You will find enclosed a copy of Service Bulletin S10RA regarding the body control module on your 2010 model year Blue Bird All American model bus(es).

Body Control Module

MODELS AFFECTED: 2010 D3FE and D3RE All American

Body Control Module

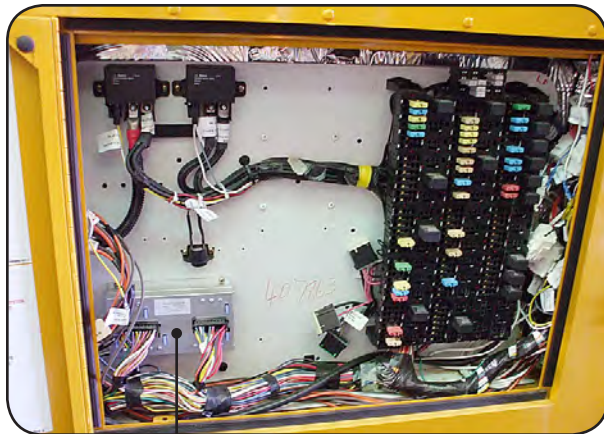
Affected buses, under certain conditions may exhibit any or all of the following symptoms related to the Body Control Module: Blown number 5 fuse. Windshield wipers sweep when the Ignition Switch is on and wiper switch is off. Stop arm activates when the Ignition Switch is switched on.

2 Locate the Body Control Module serial number at the bottom left corner of the module. If necessary, remove the mounting screws and carefully shift the module to gain view of the serial number. Compare the serial number to the list on page 2.

3.1 Disconnect the harness plugs from the module. Remove the top two mounting screws, and loosen the bottom two mounting screws. Remove the module.

3.2 Refer to the list on page 2 to determine whether the replacement is 10001559 or 10002011. Place the new module over the bottom two mounting screws. Reinstall the two upper mounting screws. Tighten the four screws. Connect the harness connectors.
